Standard Review Plan for Spent Fuel Dry Storage Systems and Facilities

Standard Review Plan for Spent Fuel Dry Storage Systems and Facilities; Request for Comment on Draft NUREG

Document: NRC-2017-0211-DRAFT-0005

FIGURE A.2

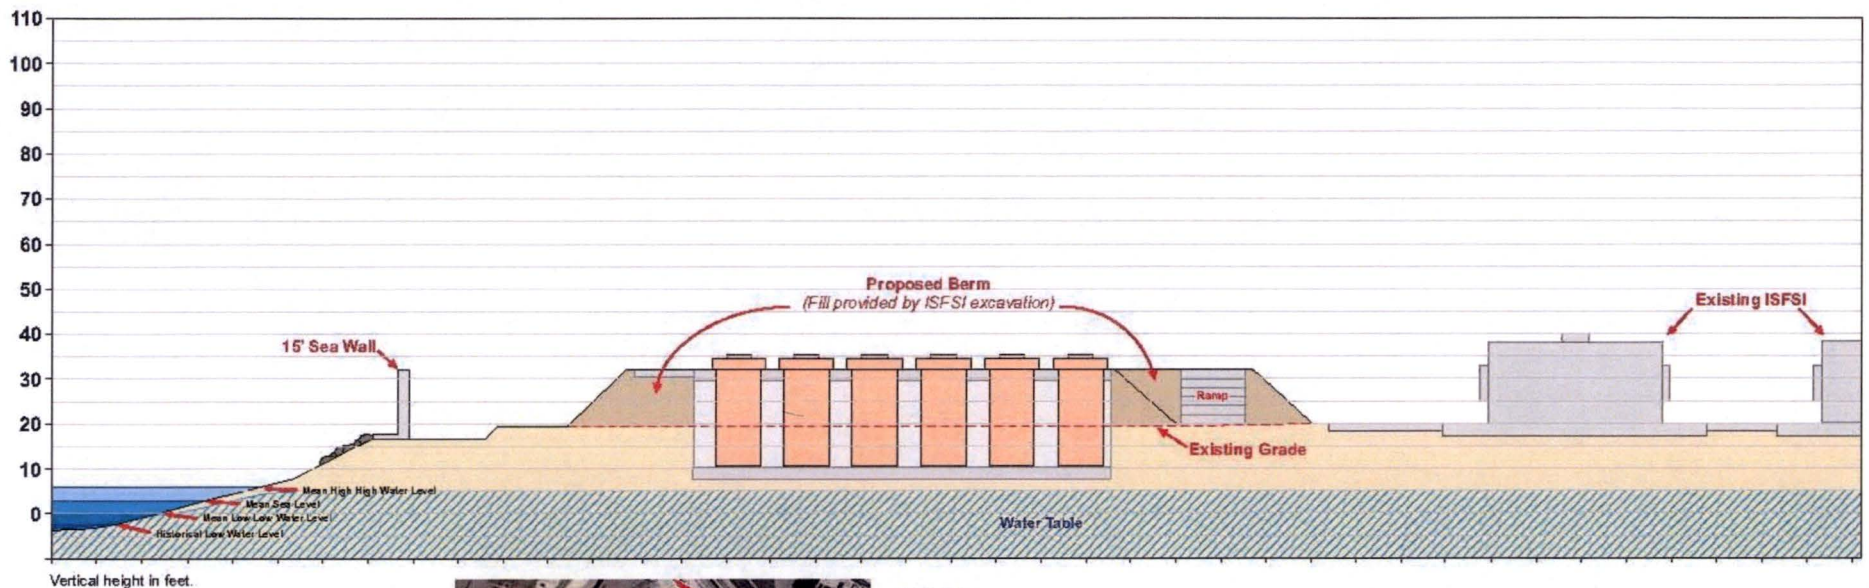
Surely they will not allow a storage system that is designed to be built 'below ground' to be built PARTIALLY below ground with less than half the height of the cans buried because a fully buried system would hit the water table.
